26 August 2021

Response to Request for Further Information - Planning Permit Application No. PA2000978, West Mokoan Solar Farm**1.0 INTRODUCTION**

Figure 2 Generation Profile – Summer Day (Source: South Energy Generation Capacity Forecast 2021)

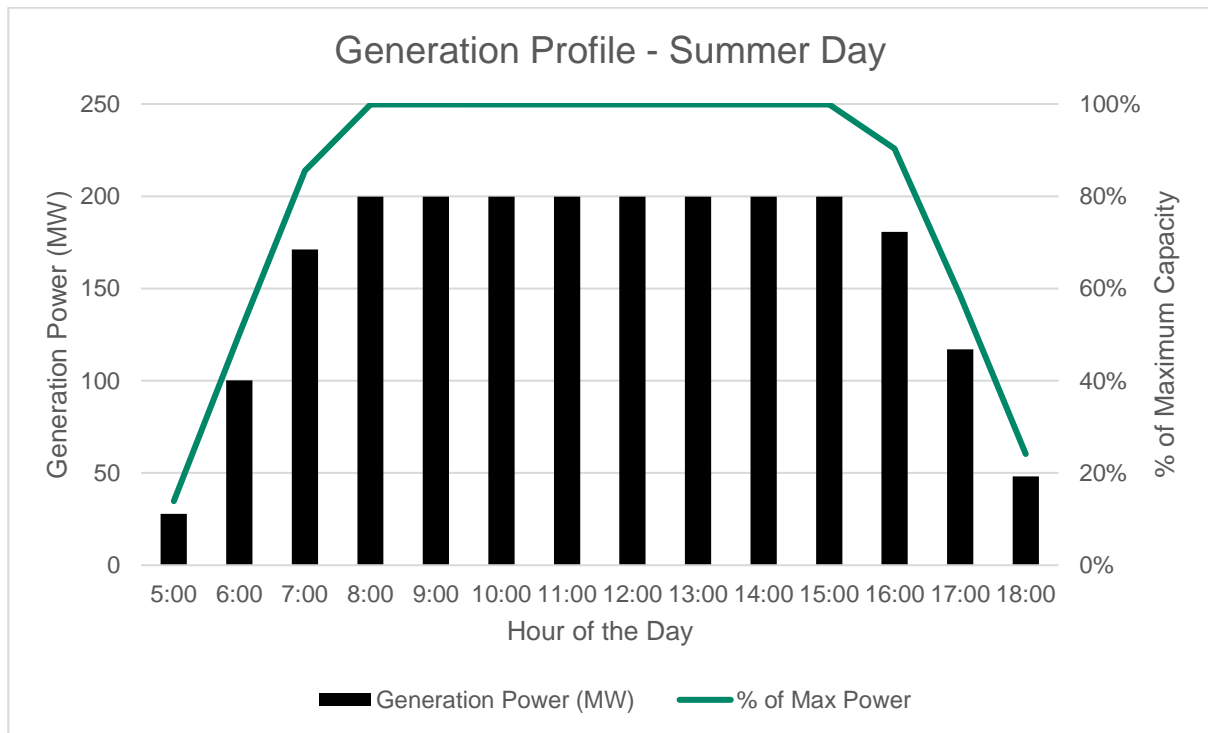
- a. Assessment of the proposal operating at 100% at all times of day, unless evidence is provided to support the assumptions of reduced capacity overnight (e.g. sufficient proof that fans will not operate at more than 50% before 7am). Based on this assessment, the report (including recommendations) should be updated to demonstrate the proposal can comply with the relevant noise limits.**

The Forecast shows that the Project will start generating power from 5am at the earliest and cease operation at 7:59pm at the latest. With regard to the 'Night period' (10pm to 7am) as defined by *Noise Limit and Assessment Protocol for the Control of Noise from Commercial, Industrial and Trade Premises and Entertainment Venues* (Noise Protocol), the Forecast shows that the Project would not operate at greater than 50% capacity within the period. There are only three instances where the

Forecast indicates 50% capacity, being 19 November and 10 and 11 December in the 6am – 6:59am time period. At all other times within the 'Night period', the Forecast shows capacity being less than 50%.

Figure 2 shows the data from the Forecast for a summer day illustrating that the percentage of maximum power does not exceed 50% within the 'Night period'. Based on this evidence, the updated Acoustic Assessment (refer to Attachment G) continues to assess the solar farm at 100% operation in the day and evening periods and 50% in the night period. The Acoustic Assessment has however been updated to confirm the mitigation proposed for the project (refer section 6.0 Recommendations) and has been updated based on the new EPA Noise Protocol.
